SUFFOLK COUNTY PLANNING COMMISSION

STAFF REPORT

Applicant:	Brightview at Port Jefferson Station
Municipality:	Brookhaven
Location:	n/s/o NYS Rte. 112 immediately west of the N Bicycle Path intersection

Received:	5/24/2018
File Number:	BR-18-05
T.P.I.N.:	0200 18300 0700 001000
Jurisdiction:	Adjacent to NYS Rte. 112

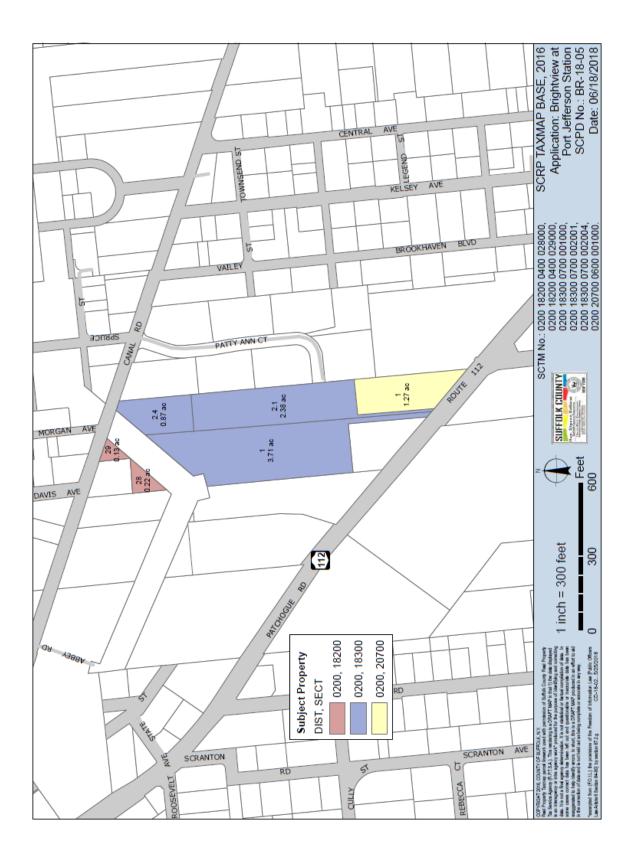
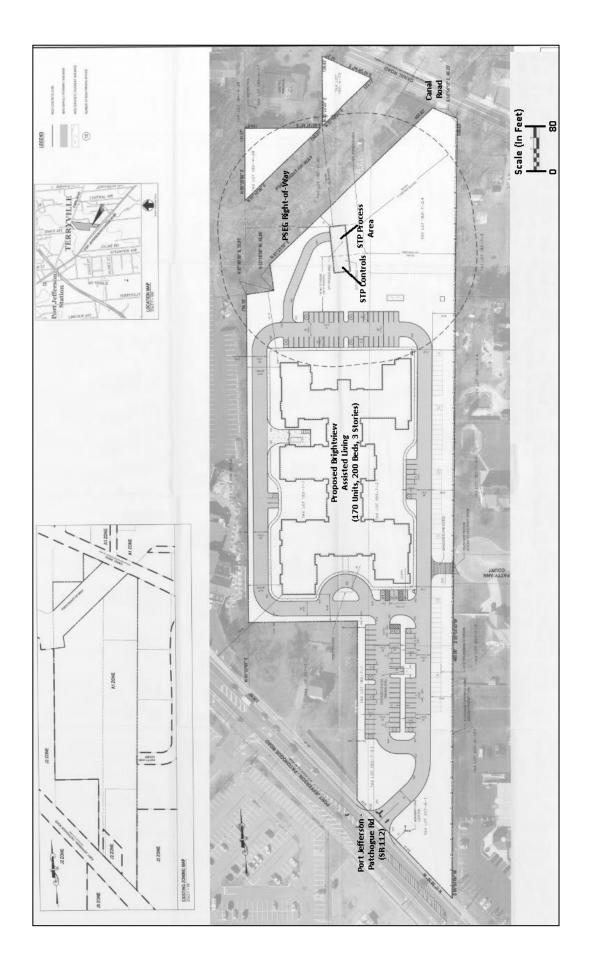
Suffolk County Transit bus route S61 traverses NYS Rte 112 with destinations to Port Jefferson (LIRR station) St. Charles and Mather hospitals, Coram Plaza, Medford (LIRR station) and Patchogue (LIRR station). Weekday service is approximately every one-half hour. The closest existing bus shelter is at NYS Rte. 347. Walking paths are non-existent in the proposal with the exception of a sidewalk around the building. There is no identified pedestrian connectivity to sidewalks within the state right-of-way.

No mention of the consideration of public safety techniques is provided in the referral material to the Suffolk County Planning Commission.
